CITY OF HAM LAKE PLANNING COMMISSION AGENDA MONDAY, NOVEMBER 14, 2022

Memorandum

Date: November 10, 2022
To: Planning Commissioners
From: David A. Krugler, City Engineer 
Subject: Bobby's Car Wash

BOBBY'S CAR WASH

5 INFILTRATION TRENCH
NO SCALE

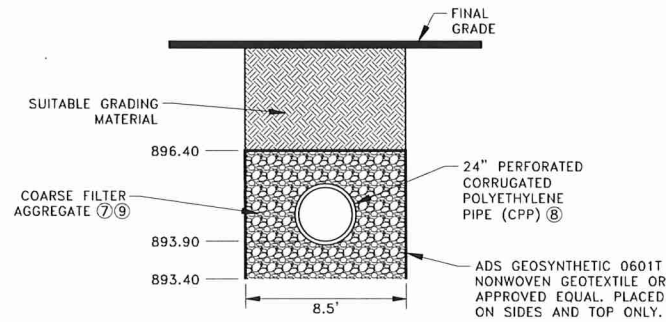
1. Receipt of Escrows.
2. Provide an O&M Agreement that meets District requirements. *-In progress*
3. Raise the bottom of the infiltration trenches to meet 3-foot separation from the seasonally high groundwater level. The bottom of the infiltration trenches should be at a minimum elevation of 893.40.

1. Receipt of Escrows. **NO**
2. Update plans with the following:
 - a. Soil boring 7 shows a 1-foot layer of silt and clay at the bottom of the proposed underground infiltration system. The system should be over-excavated to remove this layer and replaced with good draining soils. Update plans to reflect this. **YES**

- SOIL BORINGS SB-3 AND SB-7 SHOW A LAYER OF SILT AND CLAY. CONTRACTOR SHALL EXCAVATE THIS TYPE OF MATERIAL AND REPLACE WITH GRANULAR SOILS UNDER THE INFILTRATION TRENCH.

EXISTING TOPOGRAPHY AND REMOVALS PLAN
 CITY OF HAM LAKE, MINNESOTA

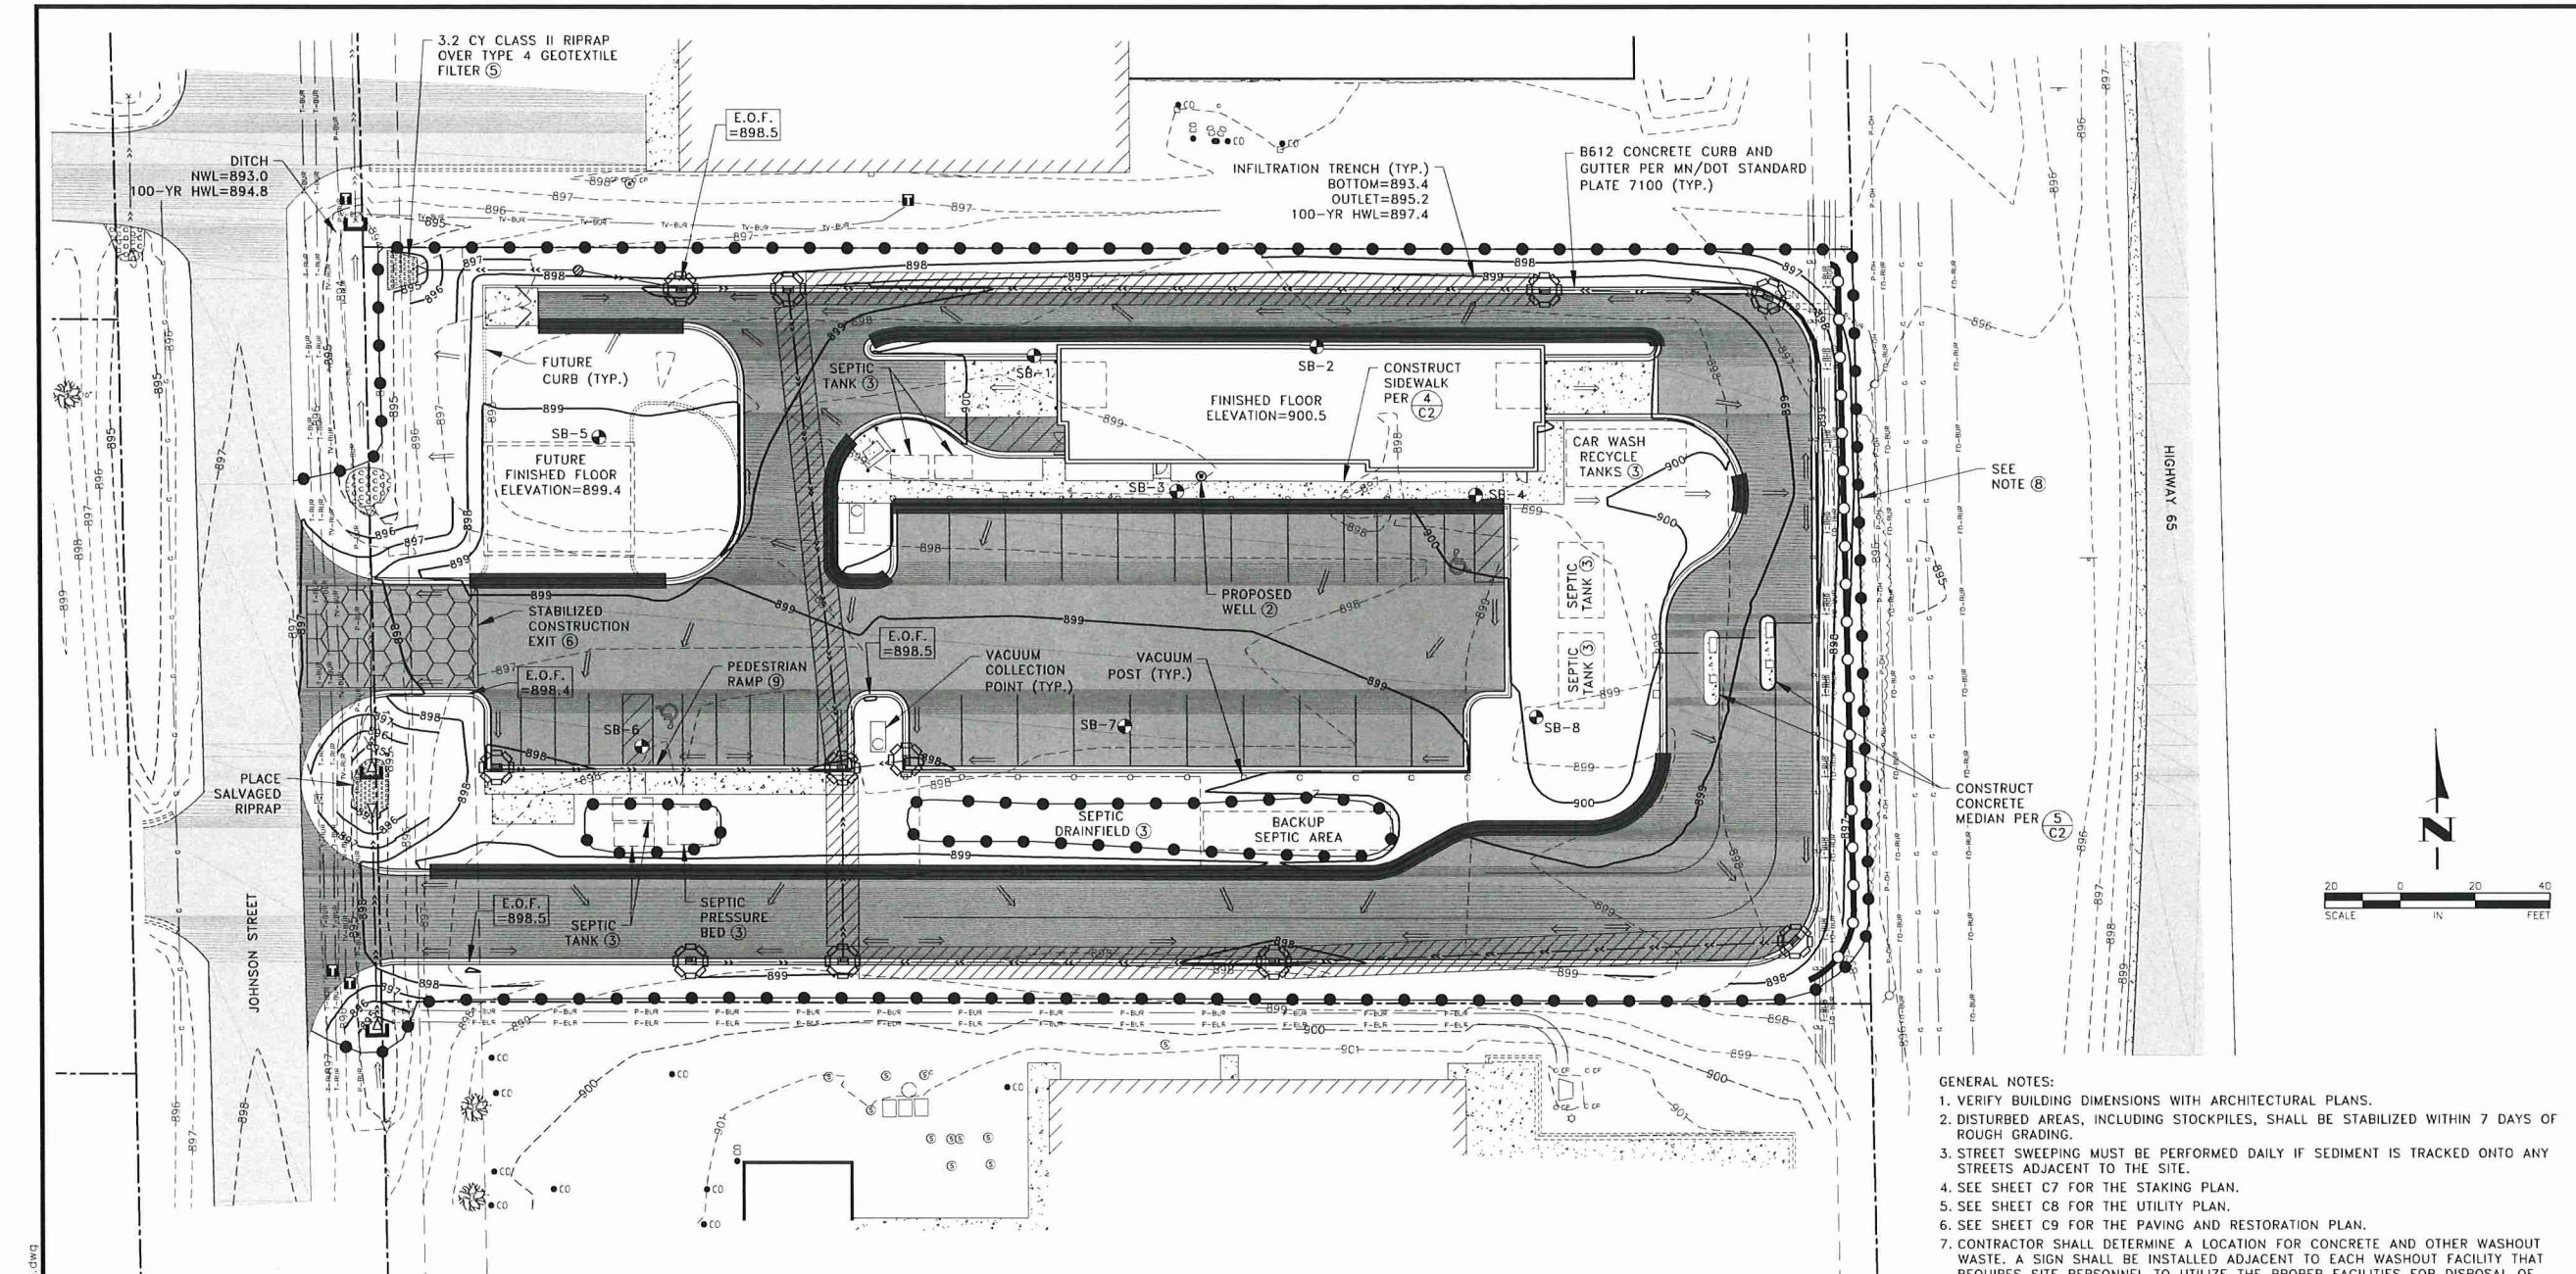
A 10-foot drainage and utility easement was dedicated over the east 10-feet of the parcel per the recorded plat of Bunker Lake Commercial Park. Per the Plans, there are public utilities on the east side of the parcel that are located outside of this 10-foot rear yard drainage and utility easement and outside of Highway 65 right-of-way. Proof of relocating these utilities being contained within the dedicated easements and right-of-way is required before the Building Department will consider the issuance of a Certificate of Occupancy.

REFERENCE NOTES:
 ① VERIFY LOCATION OF EXISTING UTILITIES. RELOCATE TO EASEMENT AS NECESSARY.

- Building Official approval of the septic designs.
- The Building Official receiving verification that the easterly utilities have been relocated to within easements and/or right-of-way prior to consideration of the issuance of a Certificate of Occupancy.

GRADING, DRAINAGE, EROSION AND
SEDIMENT CONTROL PLAN
CITY OF HAM LAKE, MINNESOTA

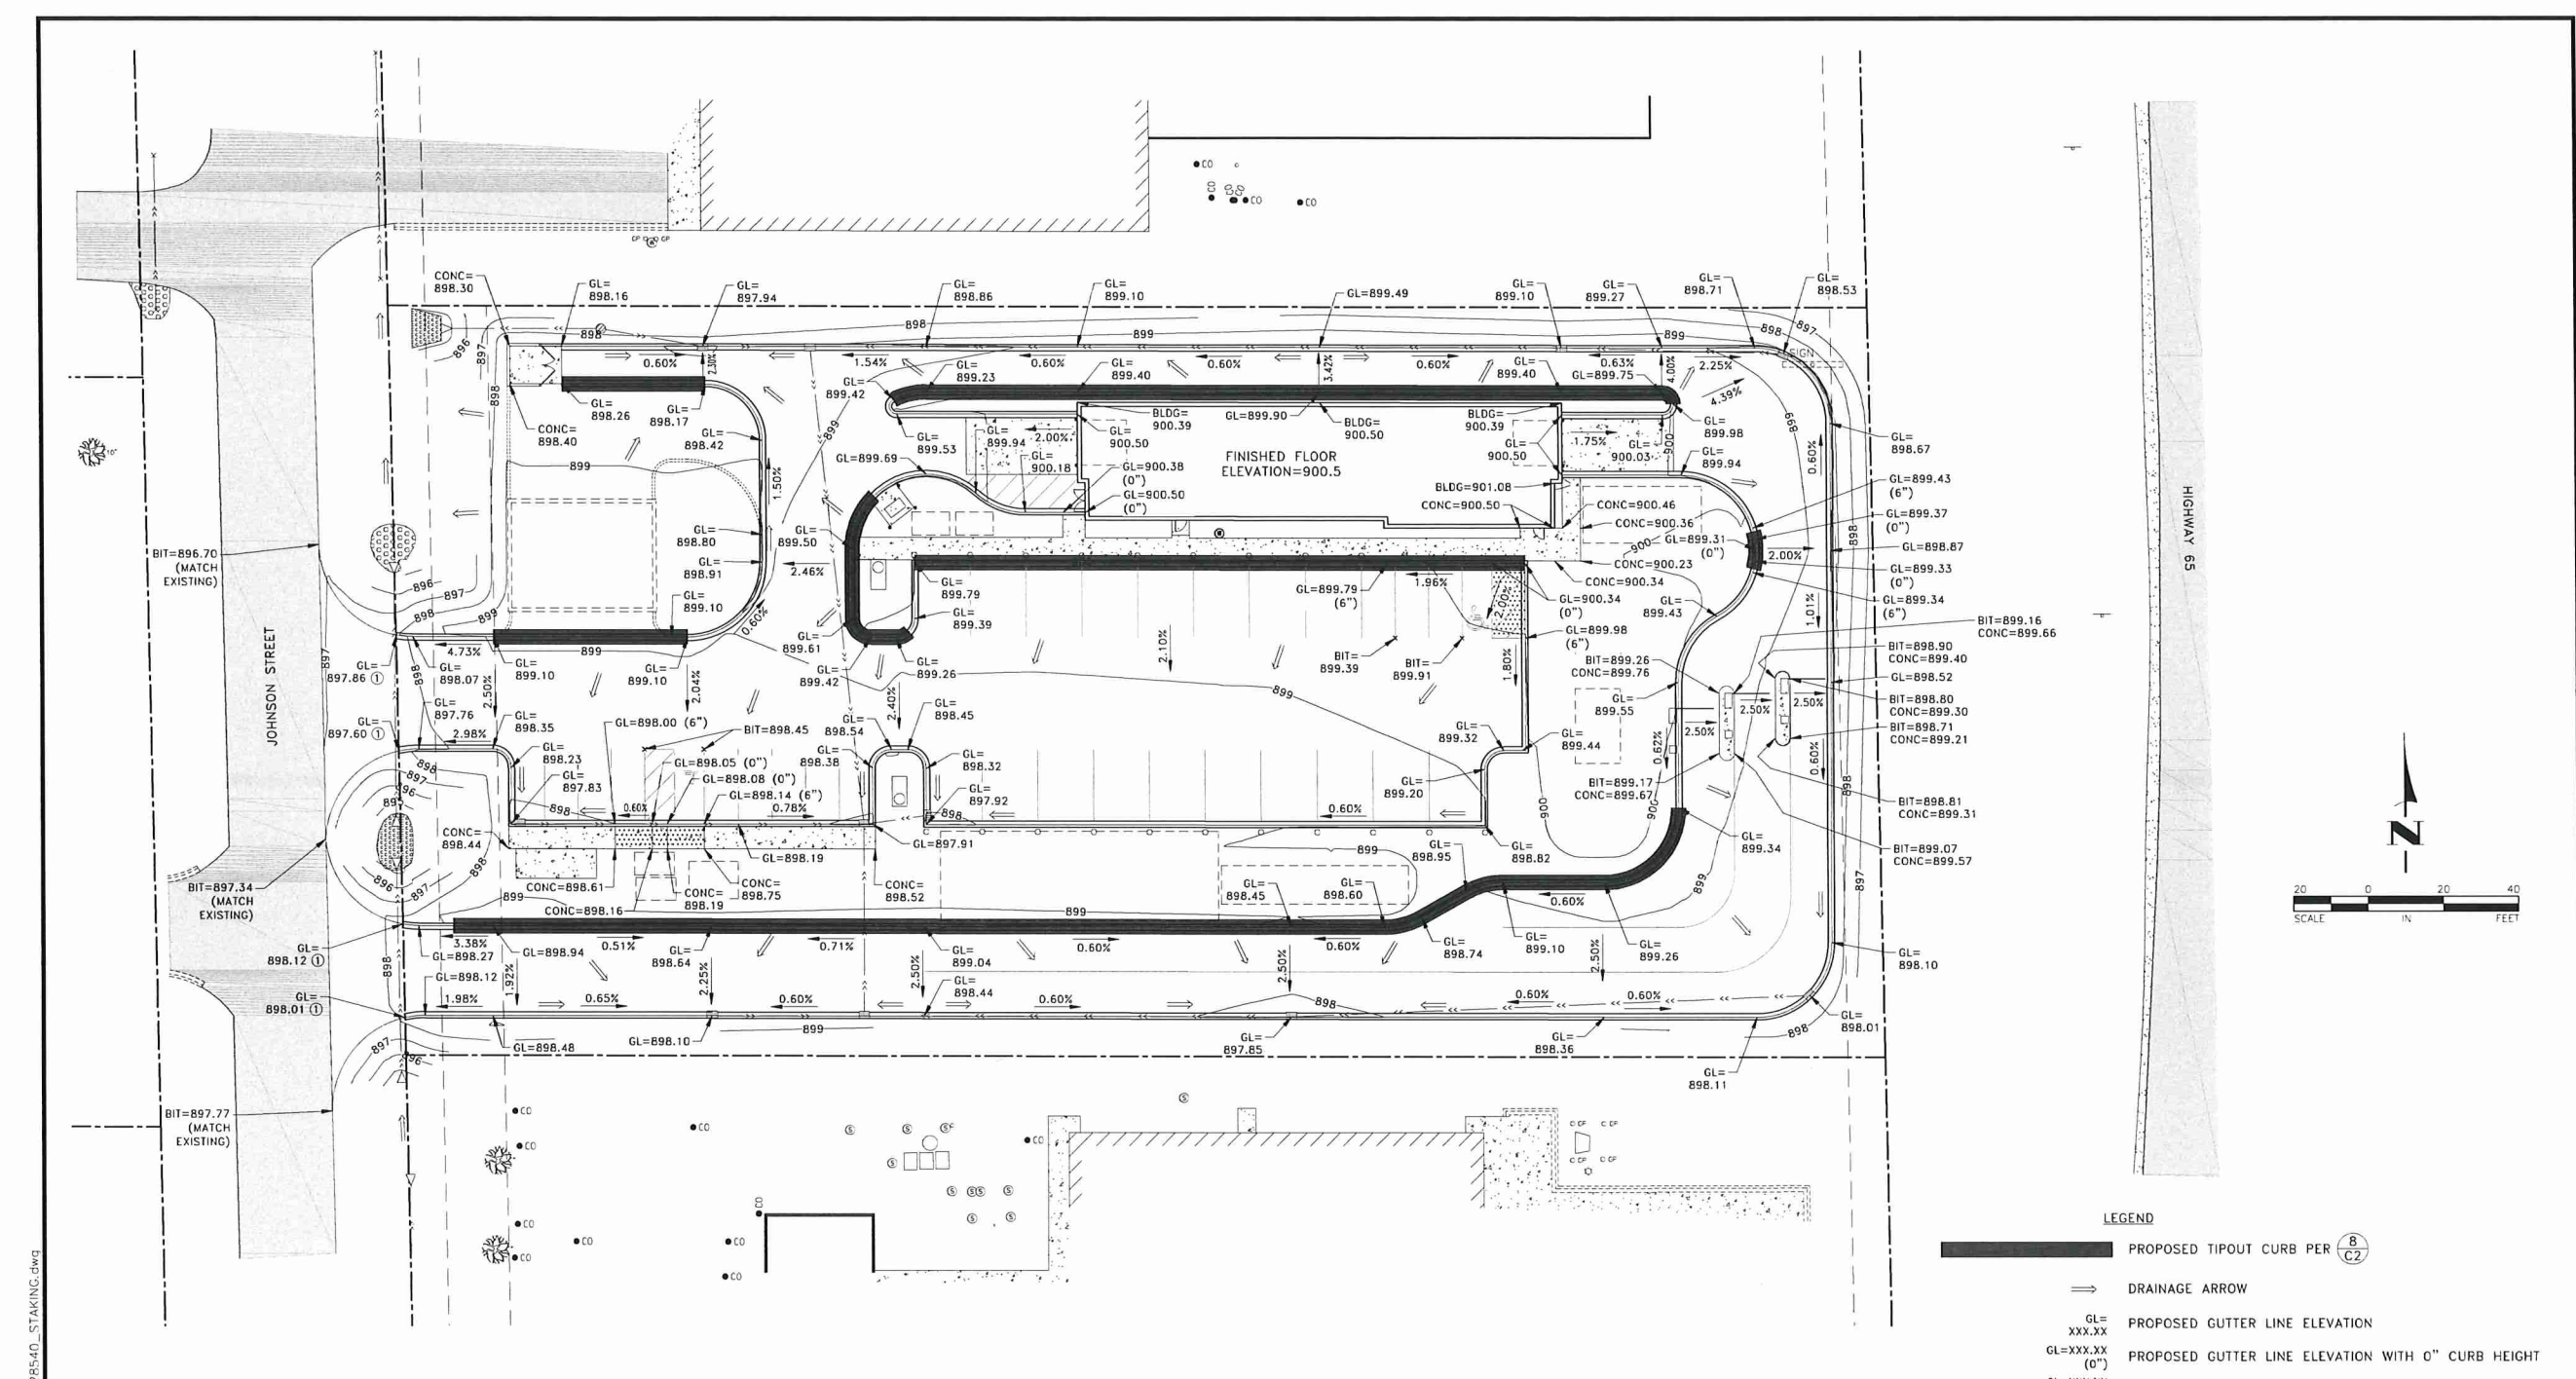
- c. Label the HWL of the underground Stormtech system on the grading plan. **YES**
3. Provide confirmation that the City has reviewed the proposed plan and that no significant changes are anticipated as a result of their review. **YES**

4. Update the construction plans to include the following:
 - a. Update construction plans to stabilize soil stock piles within 7 days of rough grading or inactivity. **YES**

- b. Provide double row of perimeter control at wetlands with a natural buffer < 50 feet on the East end of the property. **YES**
 - c. Provide note on erosion control plan that provisions have been made for cleaning road surfaces where sediment is transported by the end of the day. **YES**

- d. Clearly locate construction entrances on the plans. **YES**
5. Provide statement whether dewatering will be required for the construction of the proposed project. If yes, provide well-field location, rates, discharge location, schedule and quantities. **YES**
